Addendum No. 3

Dosker Manor Fire Alarm Replacement

FROM: Sherman Carter Barnhart Architects
2405 Harrodsburg Road
Lexington, Kentucky 40504

DATE: June 8, 2022

FAB11

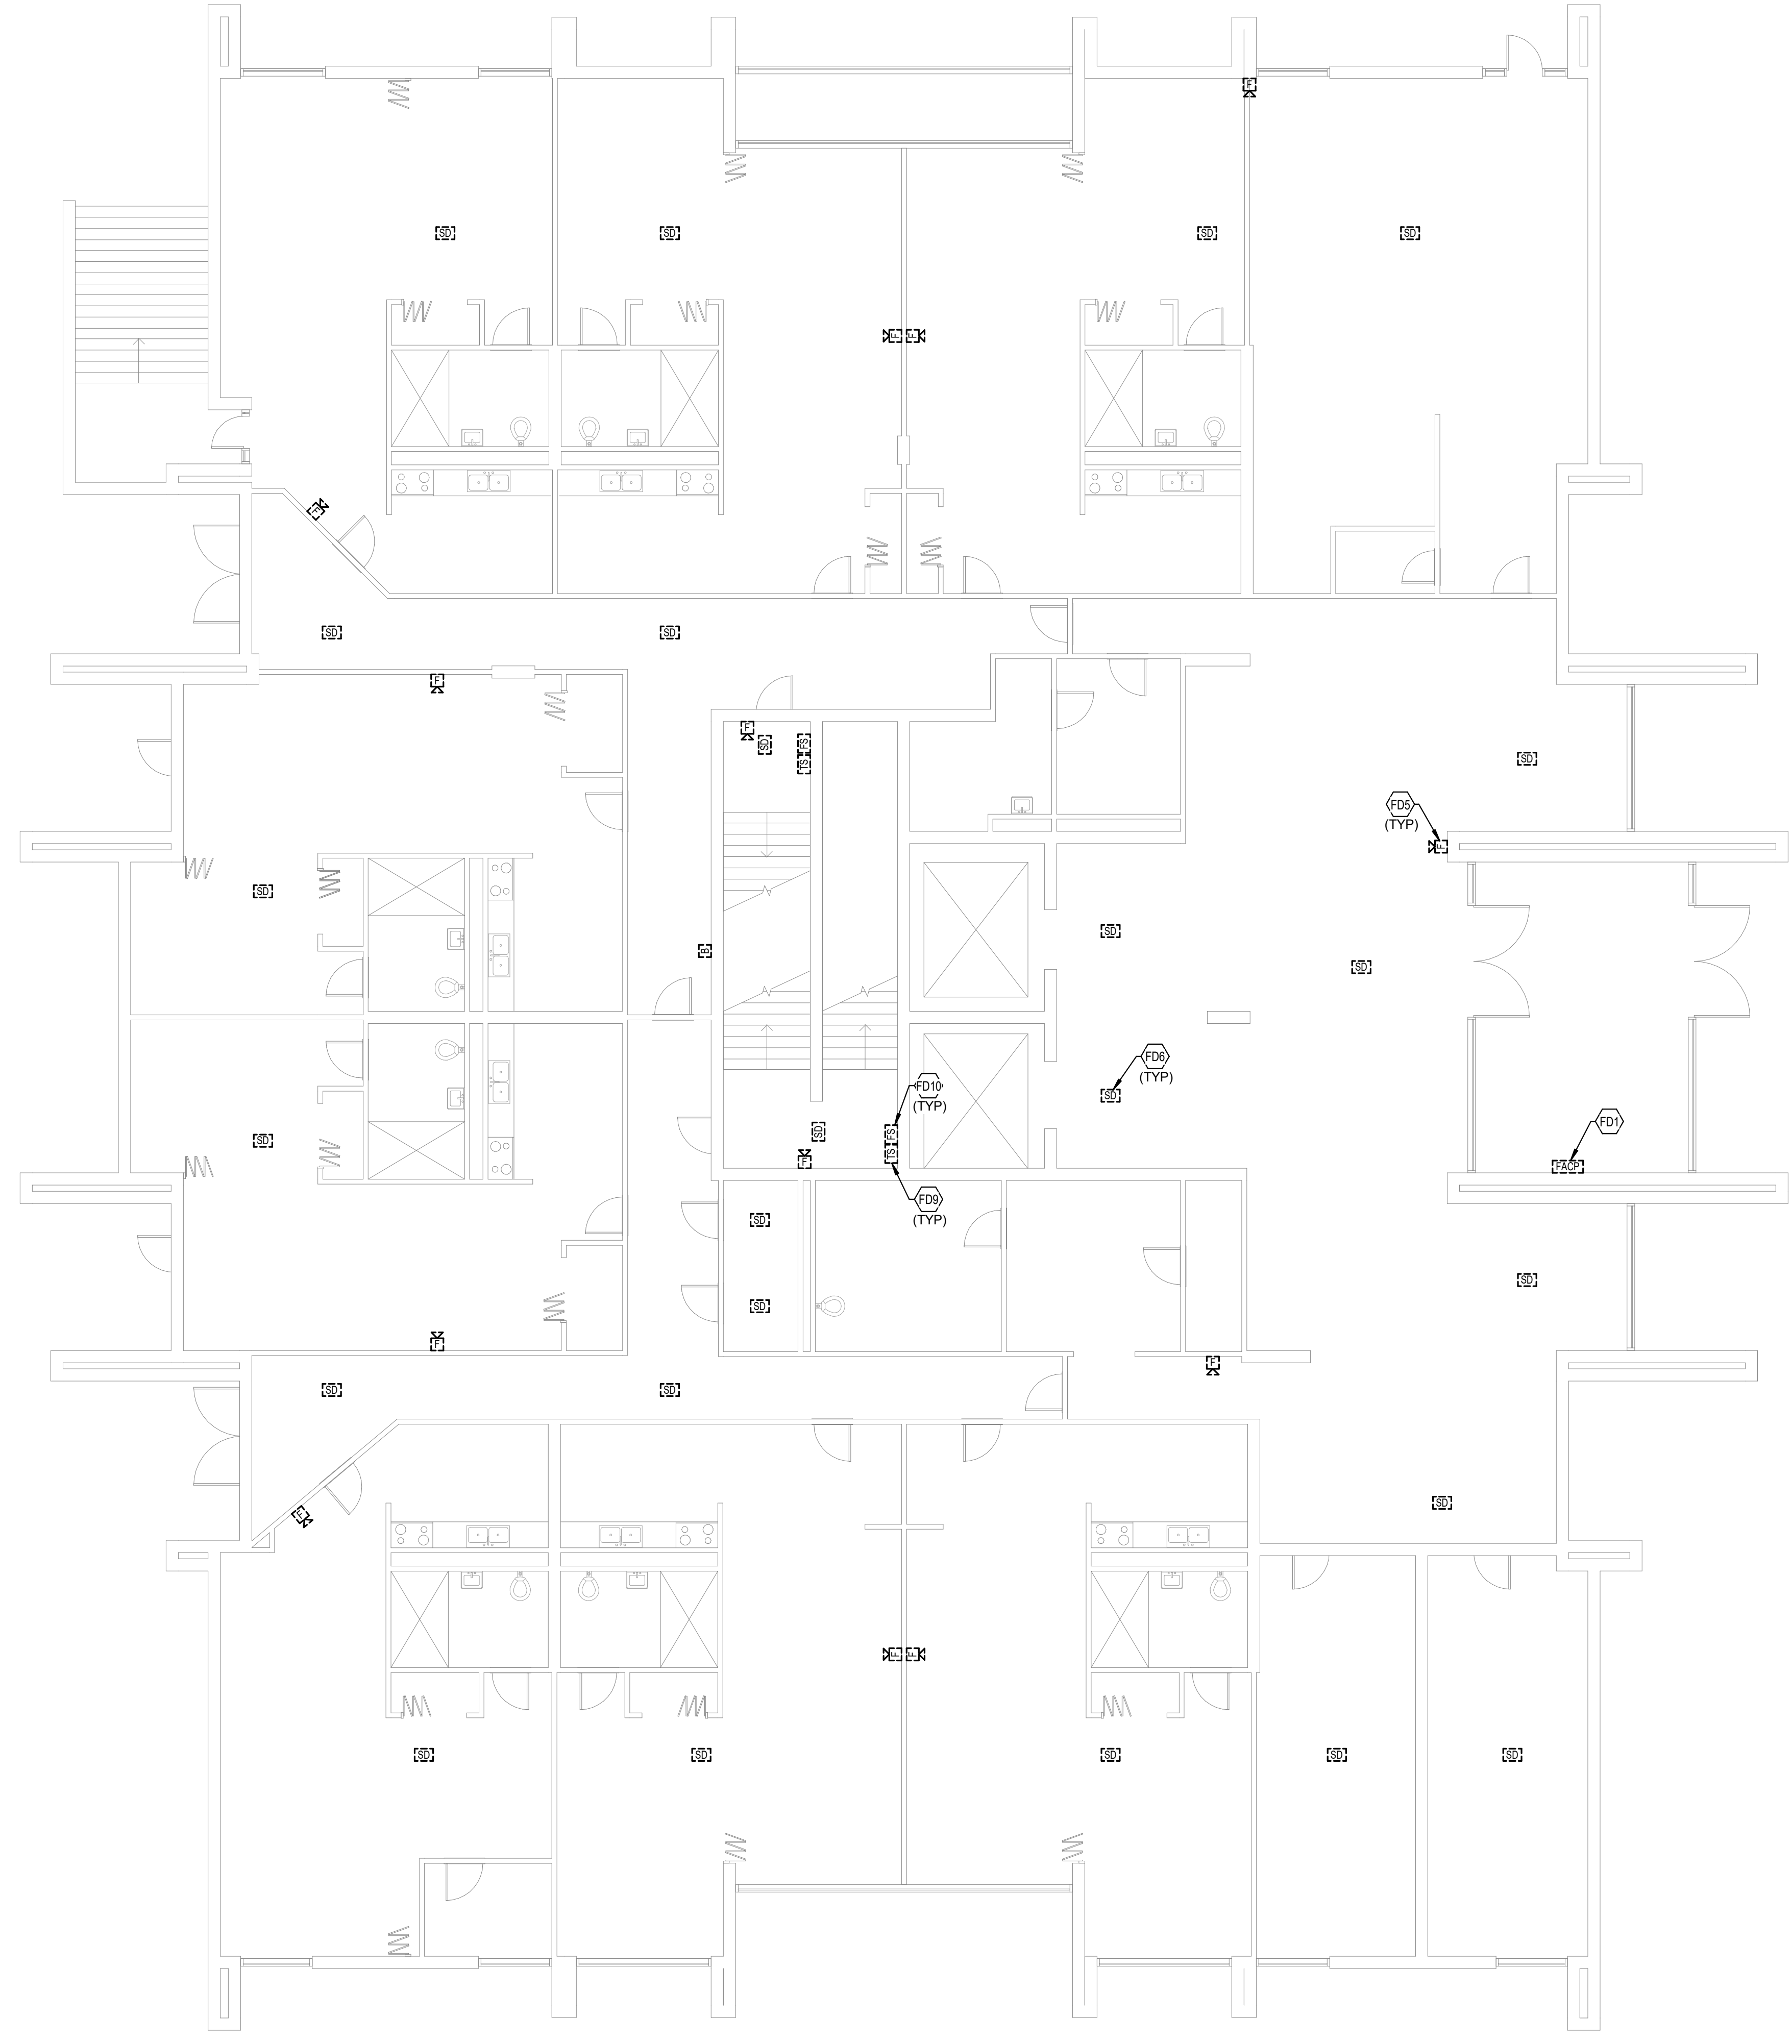
- Item #1 Refer to the Electrical Fire Alarm Notes on Sheets FAA11, FAB10, FAC11
- A. Fire alarm connections to the elevators in the buildings are in the scope of this project. Hookups are by Otis Elevator and should be coordinated in tandem with Oracle Elevators.

- B. There is no new elevator in any of these buildings. Verbiage has been removed.
 - C. There are no existing duct detectors at any of the three buildings.

- D. Firestopping note was removed as it is addressed on Sheet A1.0.
- Item #2 Refer to the Electrical General Notes on Sheets FAA21, FAB20, FAC21
- A. Mounting Heights for wall-mounted devices to comply with IECC ANSI A117.1-2009.

DEVICE MOUNTING DETAIL - GENERAL NOTES:

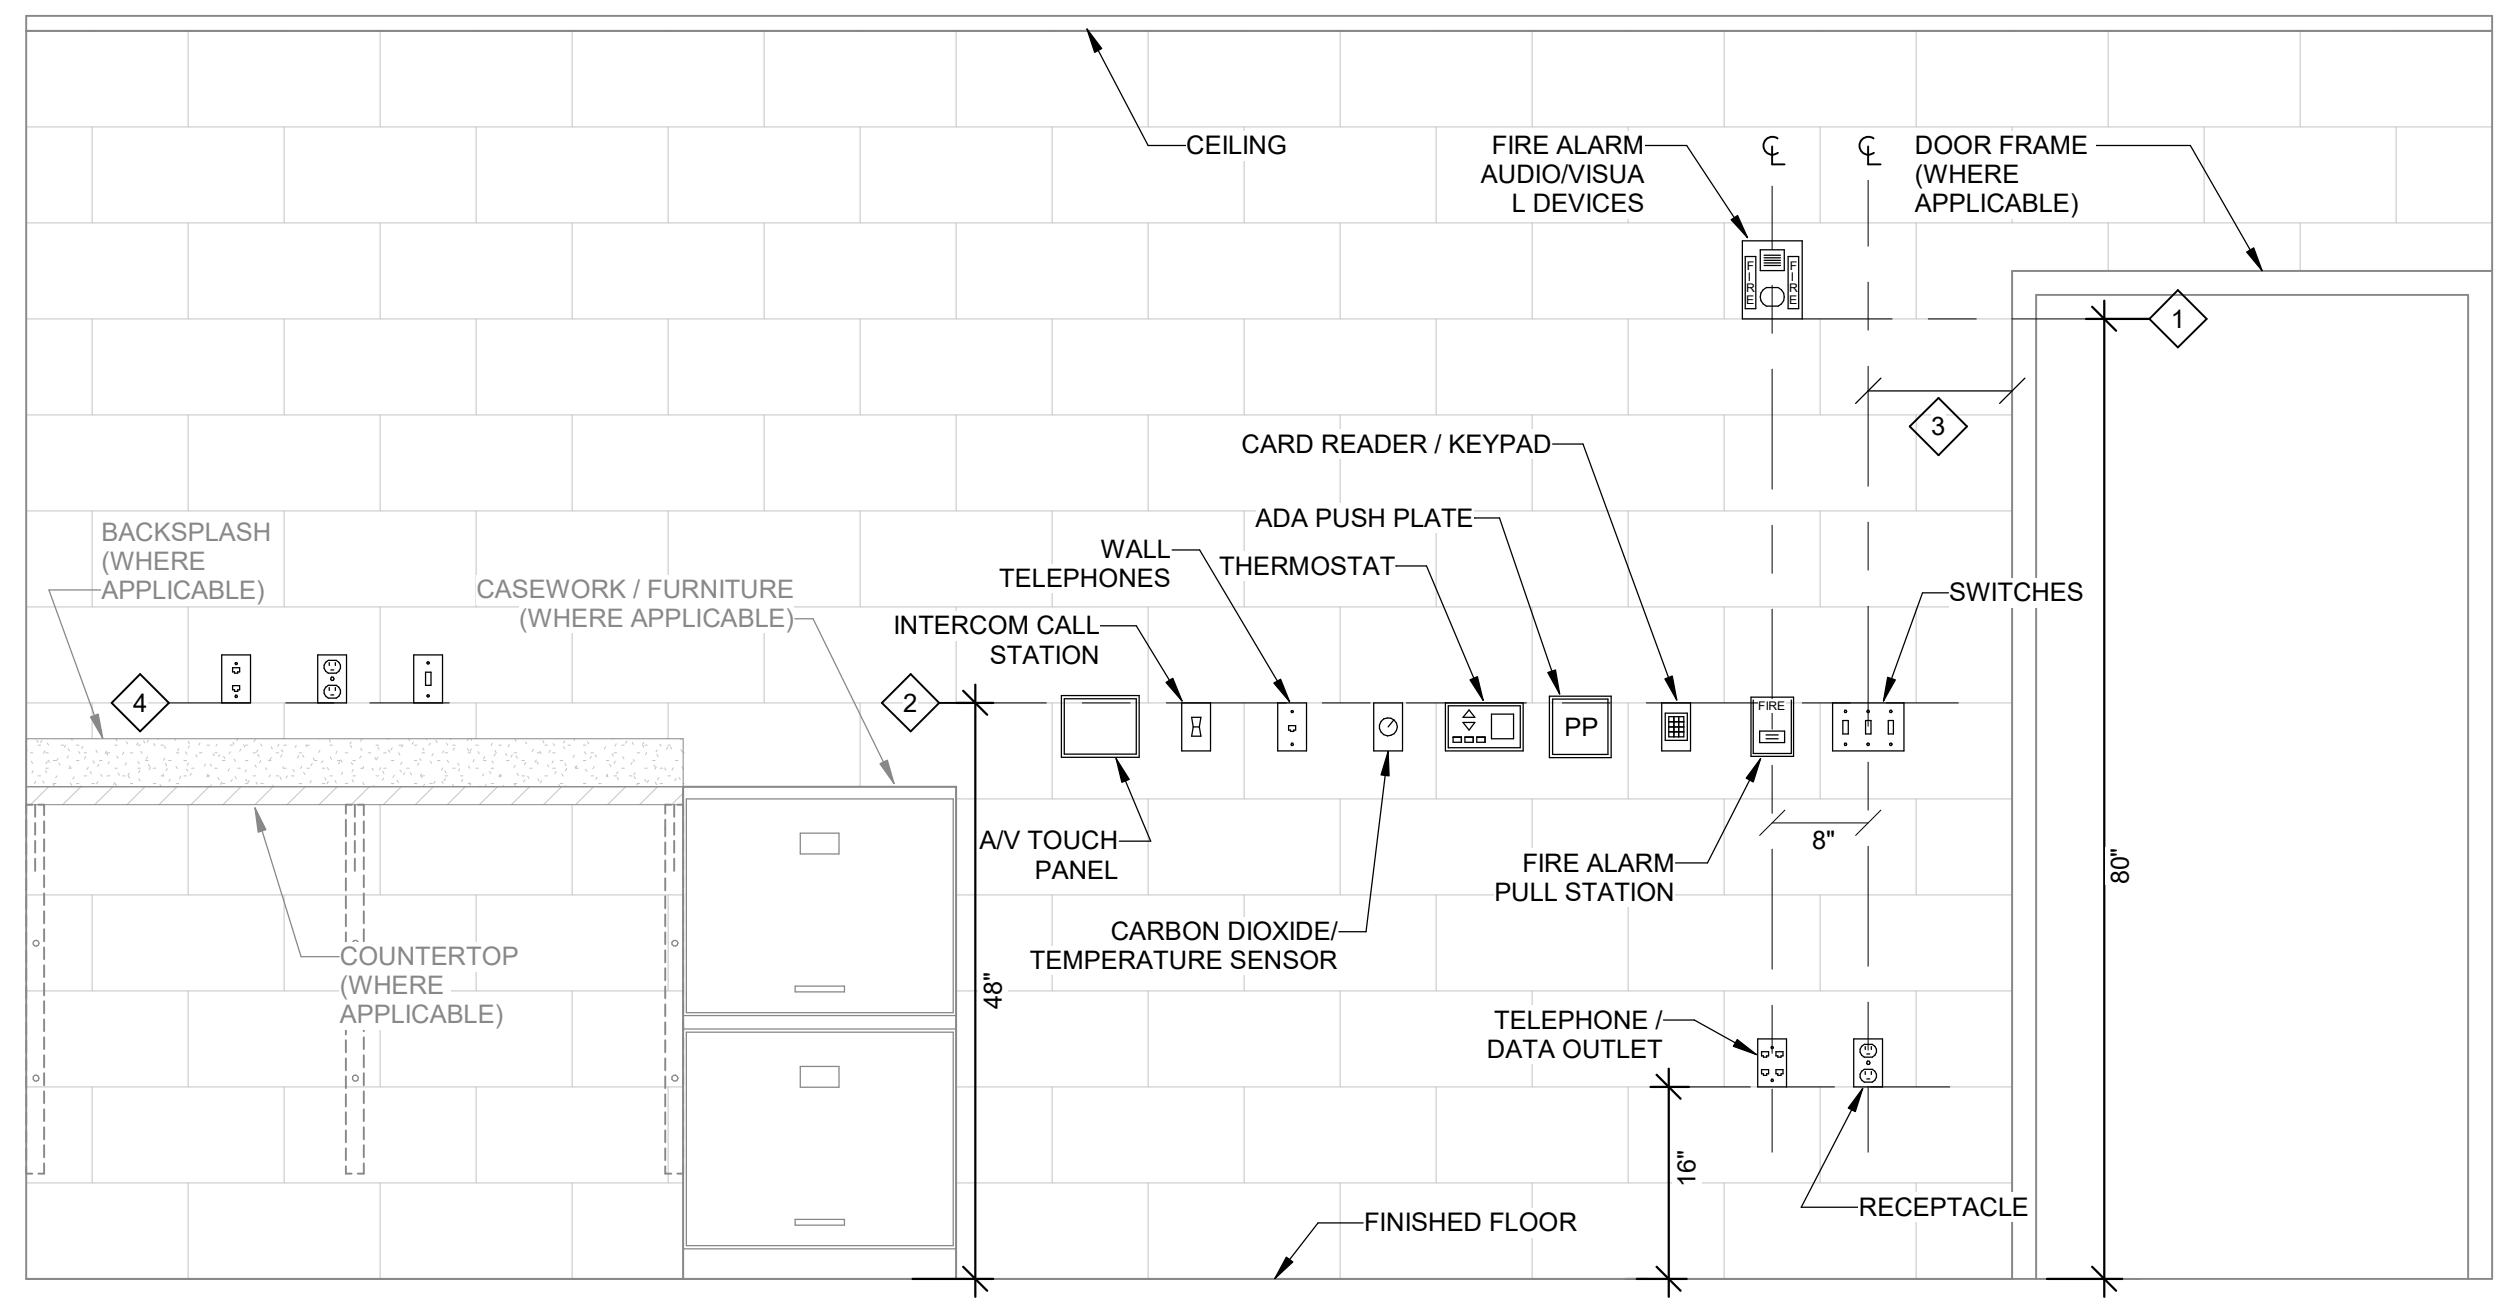
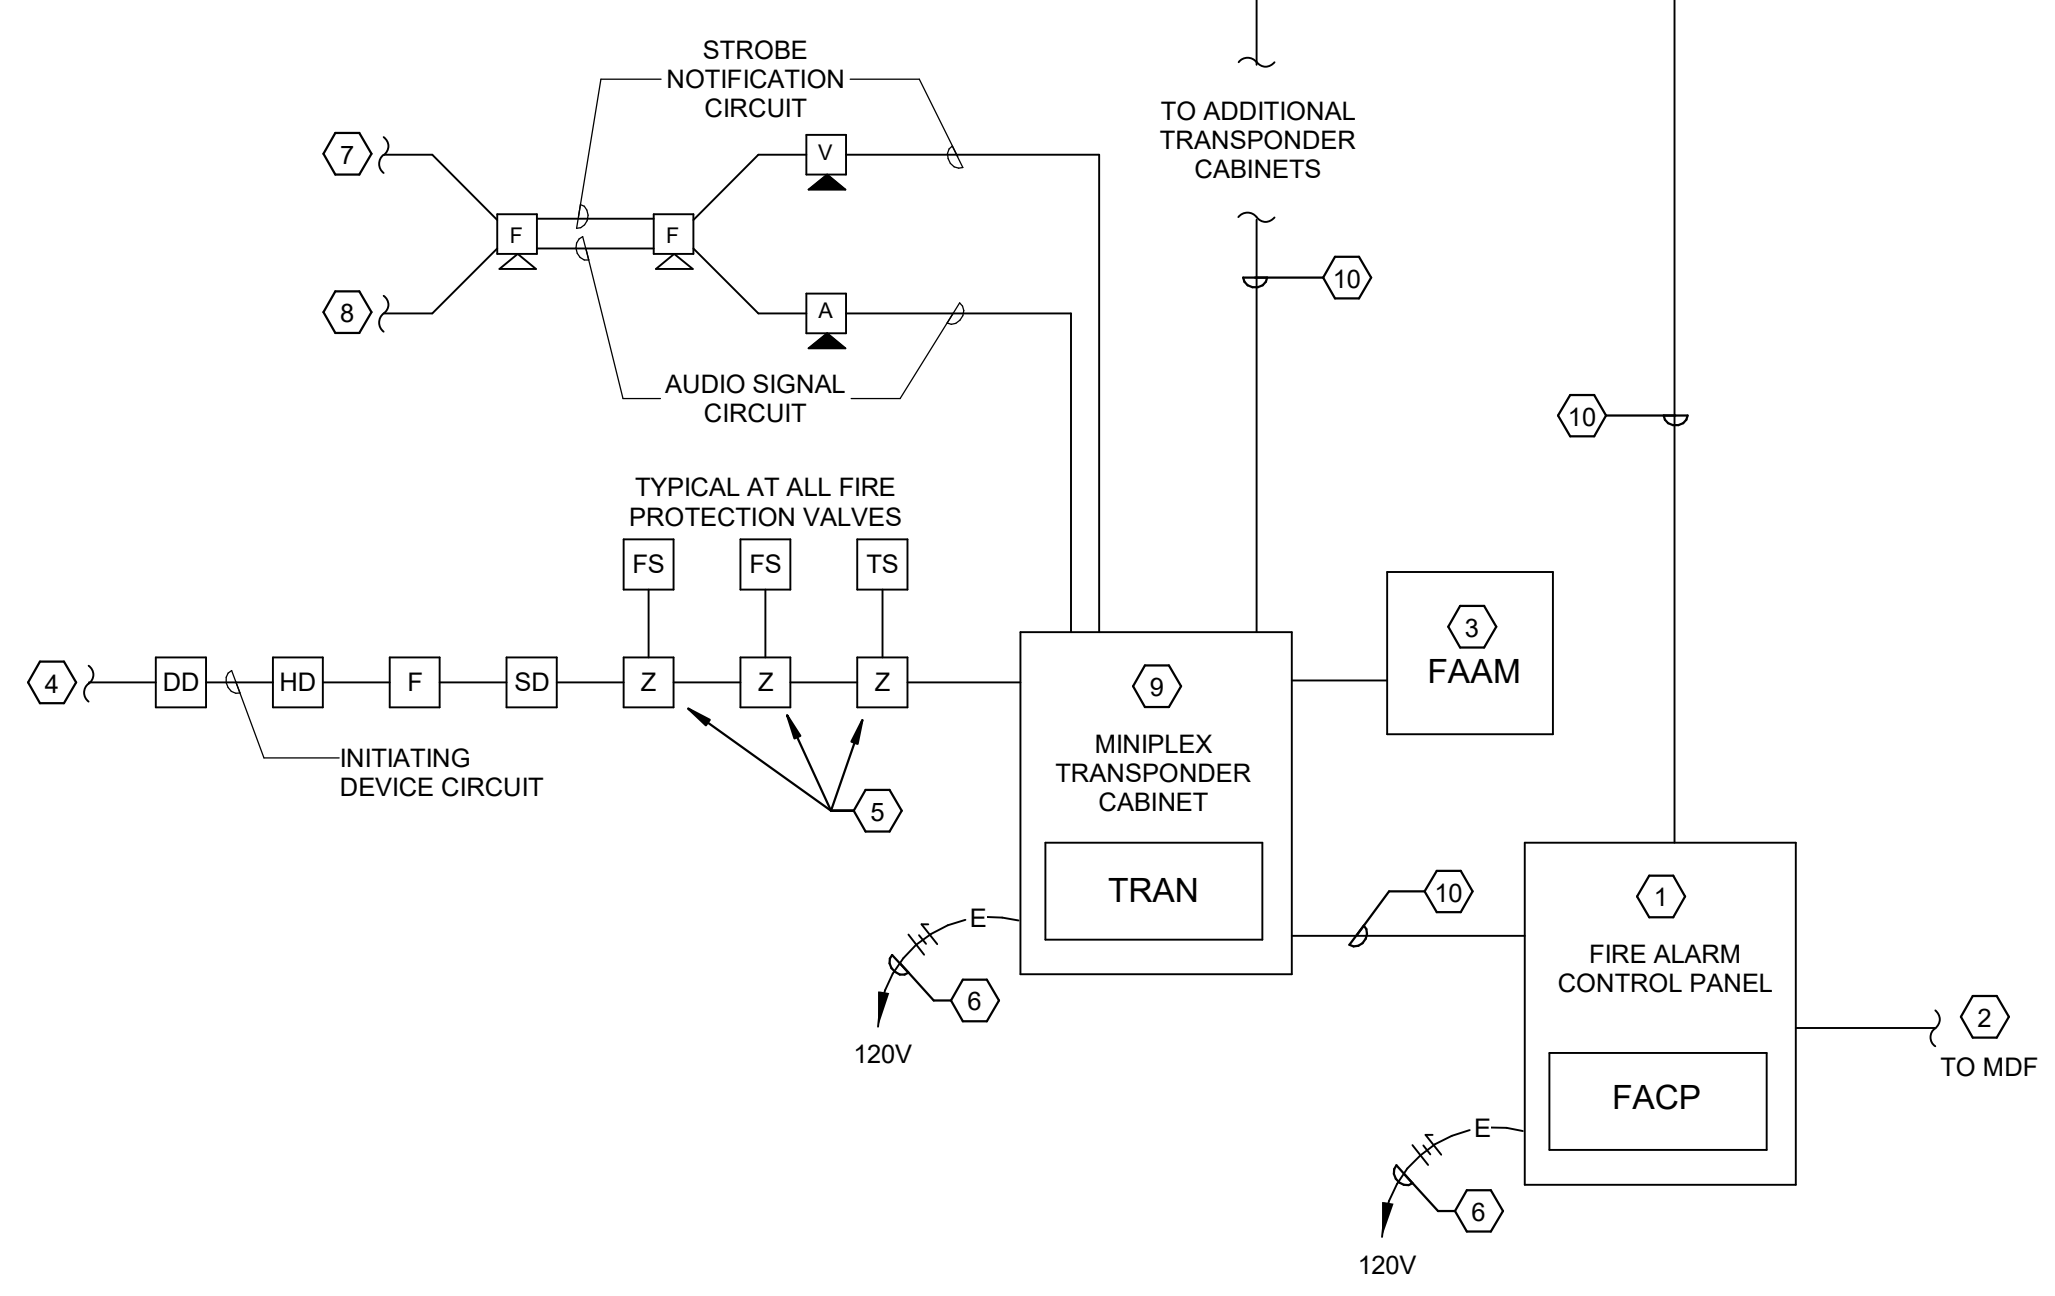
- B. Contractor to use prefinished Wiremold in lieu of painting Wiremold.
- Item #3 Refer to the Typical Wall Device Mounting Detail on Sheet FAD01
- A. Keynotes were changed from alphabetical to numerical to reflect their use on the detail.
